ADDENDUM NO. 1
INDIAN CREEK WRF EXPANSION TO 3 MGD
HENRY COUNTY WATER AUTHORITY

This addendum hereby amends and/or modifies the Contract Documents, Detailed Specifications, and Drawings, as indicated, that have been issued for this project by Engineering Strategies, Inc. Additionally, questions received by the Engineer are answered at the end of this addendum. All bidders are subject to the provisions of this addendum and shall acknowledge receipt of this addendum on the bid form.

SHEET NO.
 35-M-7

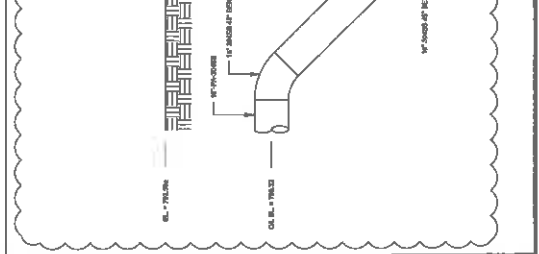
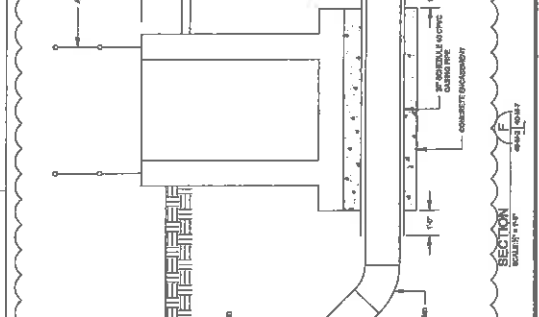
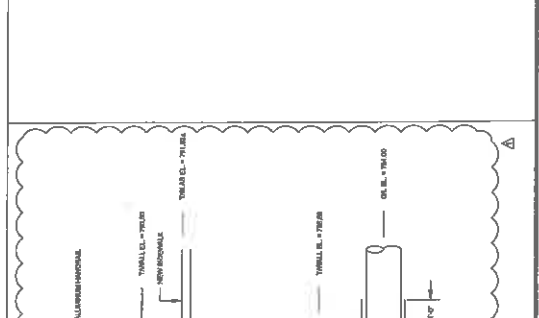
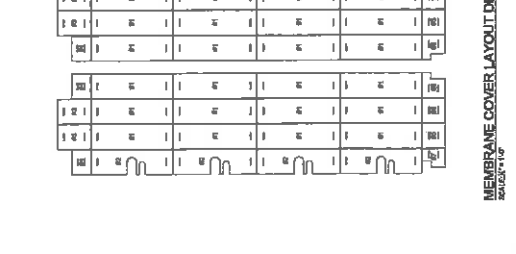
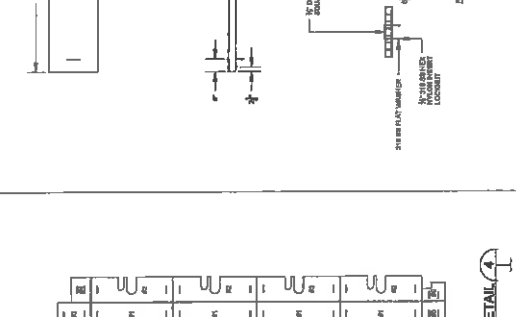
Q1-5: *Please advise a correction to an elevation on sheet 35-M-7, Section F as both ends are shown as the same elevation.*

A1-5: Detail has been revised.
